Response to comments by reviewer#2

Figure 1: Correlation between neighbouring LGD measurement locations in the northern part (left) and southern part (right).

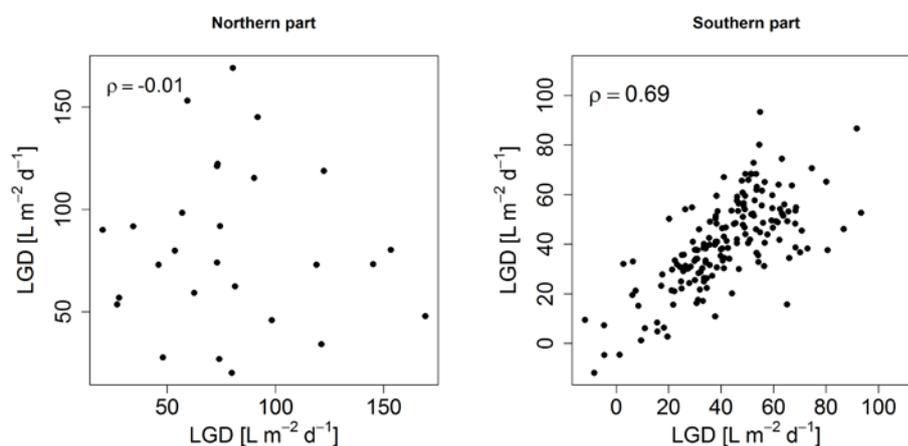
4) It is in times difficult to follow the heavy reliance on statistical treatment. For example, what is the point of the autocorrelation analysis of LGD values (e.g. page 5)? Is there a physical process associated with LGD that requires an understanding of autocorrelation of LGD along a shoreline (there is no use made of this analysis in the discussion unless I overlooked it?).

Concerning the comment on autocorrelation: this method has the advantage that it clearly addresses the question, how similar neighbored measurement locations are and up to which distance a correlation between measurement locations exist. This is exactly what we wanted to show. To reduce statistical methods, we could alternatively present correlation plots and correlation coefficients of neighbored LGD measurement locations (Lag distance 10 m, spatial resolution of VTP measurements), as presented in the figures below. We would prefer to leave the autocorrelation analysis in the manuscript, but leave the decision to the editor. However, we will include the result of correlation between LGD measurement locations within the discussion and would clarify the introduction into the method of autocorrelation in the method part as follows:

P5 L27-29: Spatial variability and correlation of LGD along different distances along the shoreline were analysed using autocorrelation plots and autocorrelation values ( $|\rho|$ ) as described in Caruso et al. (2016). High autocorrelation ( $|\rho|$ ) indicate that LGDs along a given stretch of the shoreline are correlated, whereas  $|\rho| < 0.2$ , indicate that LGDs are uncorrelated and strong spatial variability exists.

Figure 2: Sediment temperature measured 30 cm below the sediment lake interface measured during different VTP surveys are plotted against LGD rates estimated from VTPs.

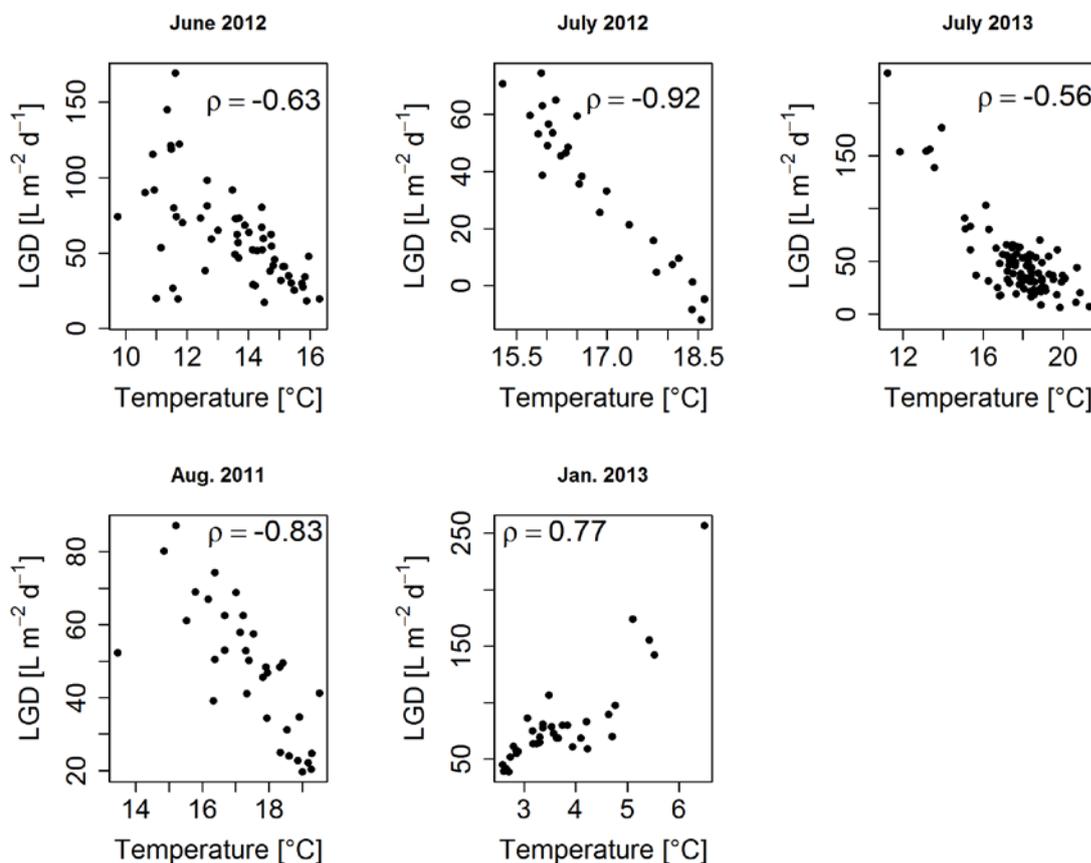
**8)** It was found that LGD correlated with grain size but not with slug test results (hydraulic conductivity). This is surprising (in particular in a large data set), and would require more detailed discussion. Were the slug tests done correctly, correct equations applied (there are a few for different experimental configurations), is there a possibility that there is a problem with the slug test results?

In the end I am a little lost what key message to take away from the ms. I believe this is likely due to ‘too much data, too much analyses’. In this light, I suggest to include a detailed account of the value of each of the applied methods (incl a comparison and appraisal of the different tools to estimate flux on

We checked the equations again, but found no problems, we also checked the correlation applying the equation of Hvorslev (1951) without the shape correction factor introduced by Chapuis (1989) and a second adaption of the Hvorslev equation even though both equation fit less well to our experimental setup. However, with both equations absolute values of estimated  $k_{sat}$  changed slightly, but calculated correlation coefficients between LGD and  $k_{sat}$  values were the same ( $\rho=-0.36$ ). Thus conclusion from measurements would be the same even by applying different equations. Slug tests were carried out carefully in the field. However, as we discussed on P 15 L31 – P16 L5, we assume that the uncertainty and errors of the slug test method are larger than the differences in hydraulic conductivity in the sandy sediment at Lake Hinnensee.

Thank you for these constructive suggestions, we will include a subsection on evaluating the applied methods (VTPs, FO-DTS, radon) in the discussion part and discuss the problems of using piezometers to identify LGD rates and patterns due to uncertainties in  $k_{\text{sat}}$  estimations. Furthermore we will give a recipe how to design a good study. In this part we would also emphasize the advantages of using a needle for measuring sediment temperatures, because this instrument allows precise sediment temperature measurements without disturbing the sediment and the flow. Furthermore, we will evaluate the use of temperature measurements from one single sediment depth (instead of the entire profile) to get a fast impression of LGD patterns and will therefore present correlations between LGD rates estimated from VTPs and sediment temperatures from different depths of the profile. Sediment temperatures from the top of the sediment down to a depth of 10 cm were not well correlated with LGD rates, but strong correlations were found between LGD rates and sediment temperatures measured 20 cm below surface and deeper (correlation coefficients range between 0.46 and 0.96 and see figure below). Measuring sediment temperatures only in one sediment depth instead of complete VTPs would save a lot of time in the field. A discussion of these points will be included in the revised manuscript.
